SPECIAL USE REPORT

▶ **FILE #:** 4-A-21-SU

▶ **APPLICANT:** EMERALD YOUTH FOUNDATION

▶ **PROPOSED USE:** Field lighting

SE1

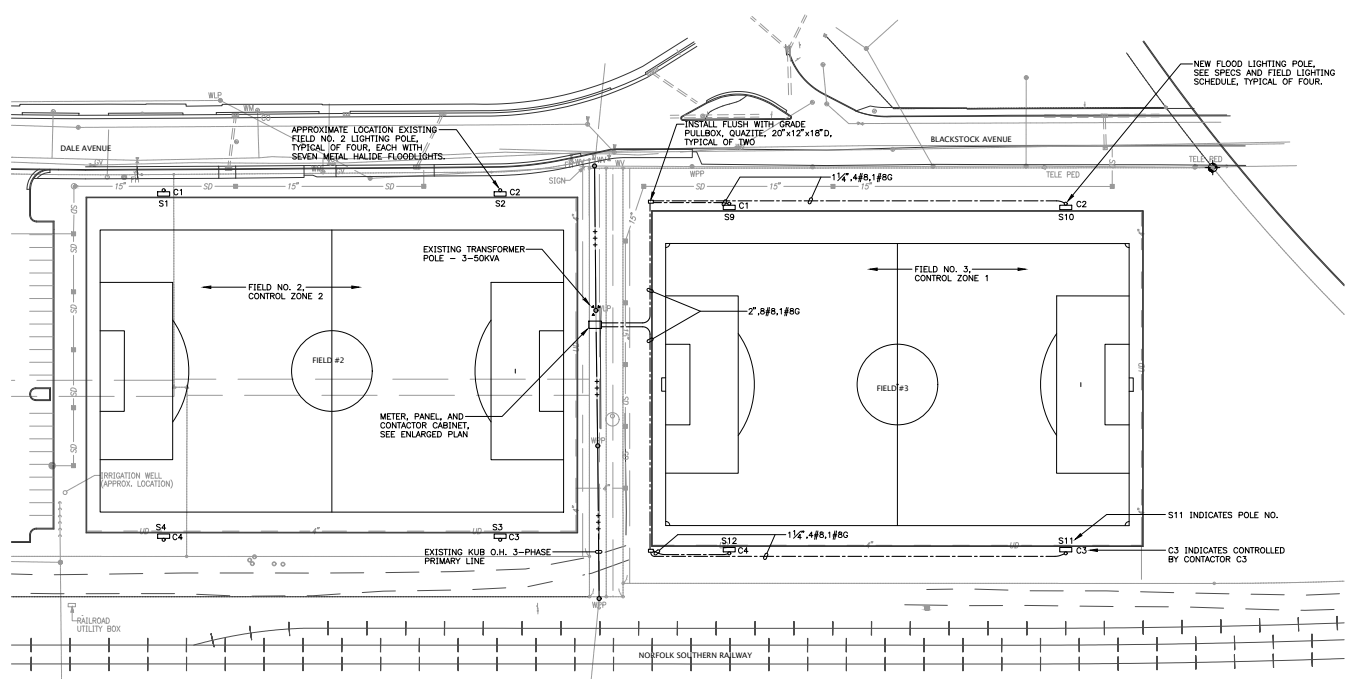
- C. Proposed light fixtures are full cutoff and meet ordinance requirements.
- D. The proposed light poles are located over 140 feet from the nearest residential dwellings (the minimum distance required is 15 feet).

C. Proposed fixtures are full cutoff, minimizing glare from light fixtures.

D. Proposed luminaires utilize LED lighting, which provide more control of illumination with less spill than other lighting types.

G. The distance between the parcel housing the soccer fields and the parcels with residential uses measures approximately 143 feet at field 3, across the railroad tracks and Grand Avenue from residential dwellings. This is well above the minimum required in Article 10.2.B (Lighting Standards).

▶ **Approve the request for new 70-ft tall light poles, subject to 2 conditions:**

1. Meeting the requirements of the City of Knoxville Zoning Ordinance, Article 10.2, Exterior Lighting.
2. Meeting all applicable requirements of the City of Knoxville Department of Engineering.
